From: John L. Yu <jjohnny@yahoo.com>
Sent: Friday, January 26, 2018 1:59 PM
To: Planning Service; Sean Gallegos
Cc: John Yu
Subject: Objection to 1261 Saint Joseph Avenue Design Plan
Attachments: fig 1.jpg

Subject: 17-SC-35---1261 Saint Joseph Avenue PLEASE INCLUDE THIS NOTICE / LETTER IN THE DESIGN REVIEW COMMISSION MEETING DATED 1-31-2018

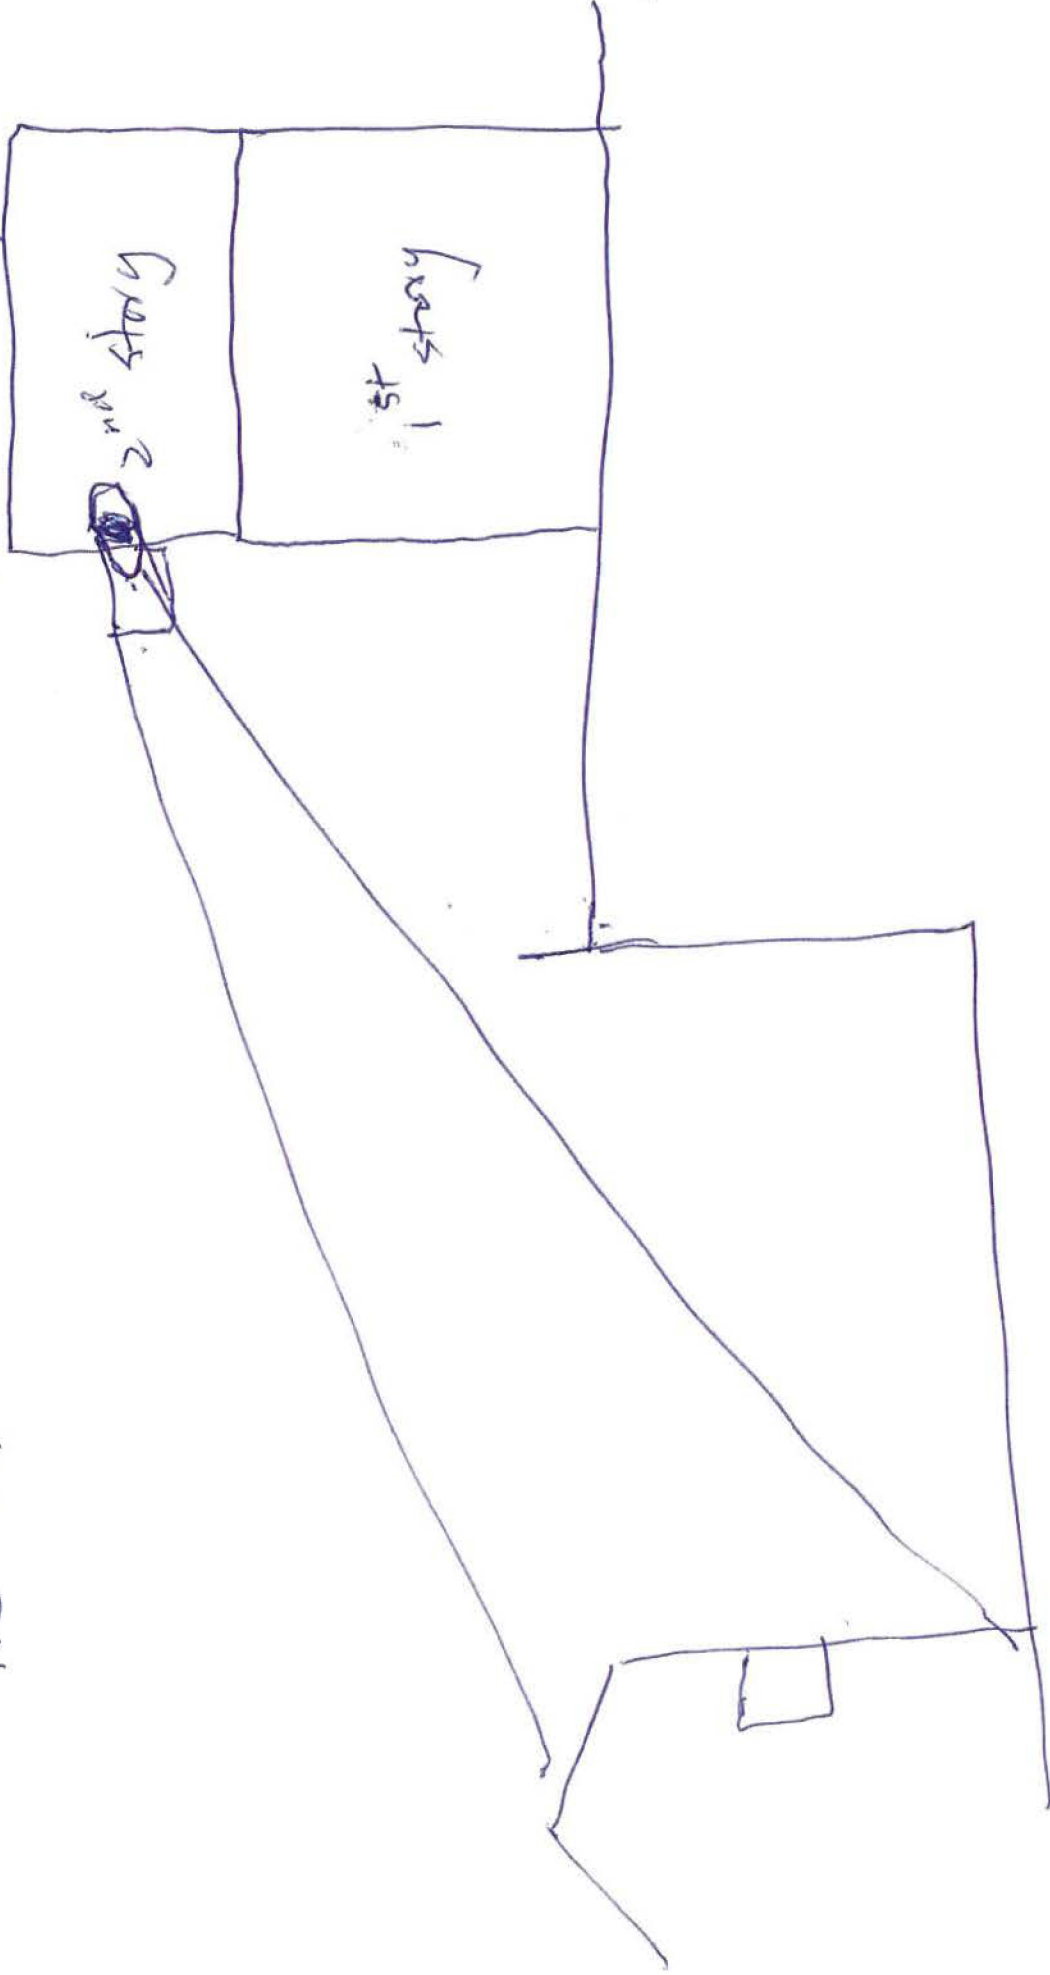
2. **Loss of view..** Our lot is about 10 ft lower than that of the proposed 2-story house (see Fig. 1). As such, the open space and view of the sky from our back yard will be significantly blocked and impacted by the proposed height of the structure on top of the 10 ft height difference in our lots (for a total of 37 ft.) The large build out and over-development on the lot behind us will also reduce the feeling of spaciousness, openness, and greenness that is a major part of the appeal of living here.

3. **Out of scale and character for our neighborhood.** The design is very bulky and massive (4,252sf and 1,785sf basement) in comparison to the homes in our neighborhood. It's height (26.5ft) is out of scale for the 'low profile' of the neighboring homes and will overwhelm ours especially since the lot is already 10ft higher than ours.

Full day sunlight and shadow analysis on future 2-story house_1261 St Joseph Ave

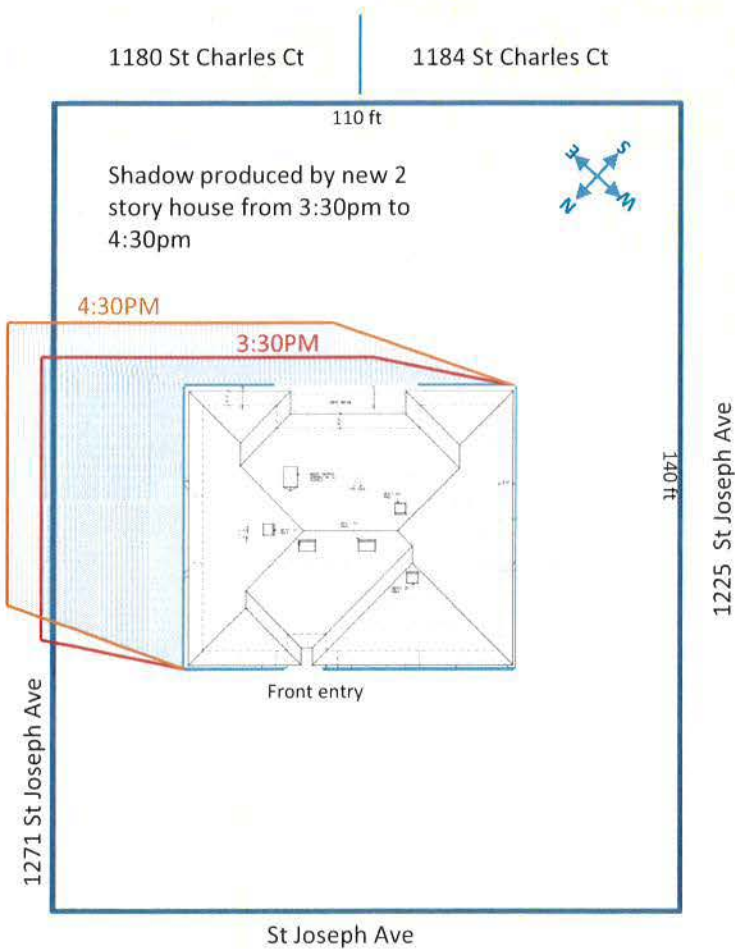
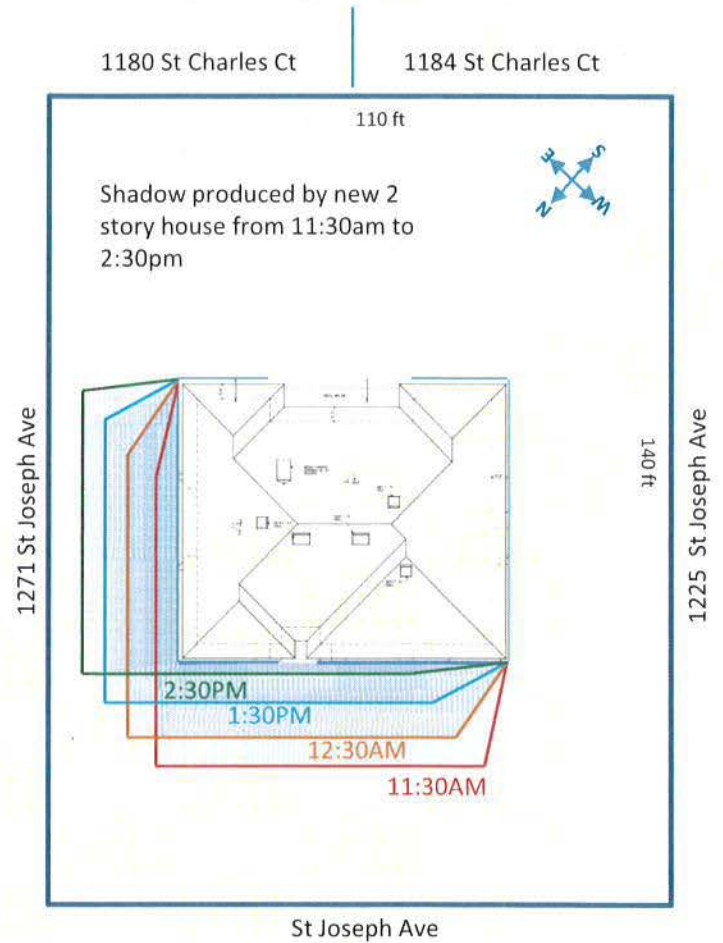
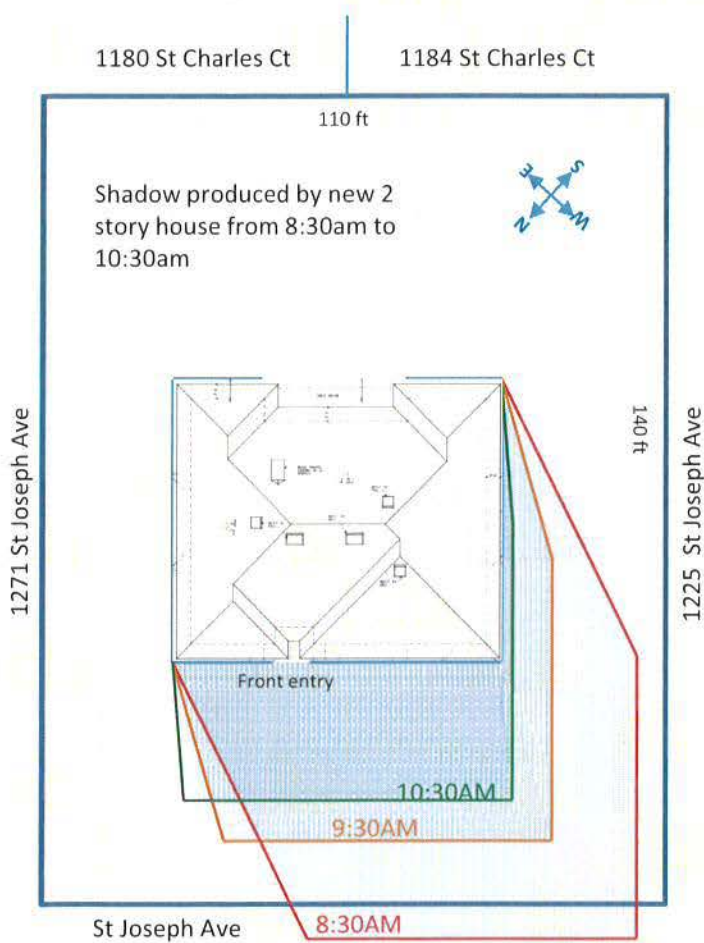
- **Access to daylight:** The height and position of the proposed building, which is even closer and taller than the current building, will leave our yard in near constant shadow. The result being not only a profound loss of enjoyment, privacy; but insufficient light to maintain a green garden.

How is it measured and calculated?

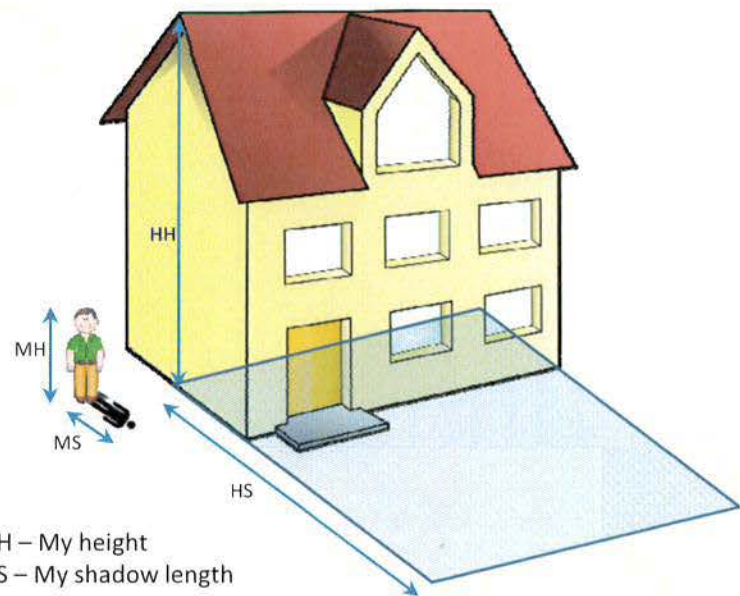
MH – My height
MS – My shadow length
HH – House height
HS – House shadow length

$$\frac{MH}{MS} = \frac{HH}{HS} \rightarrow HS = (MS * HH) / MH$$
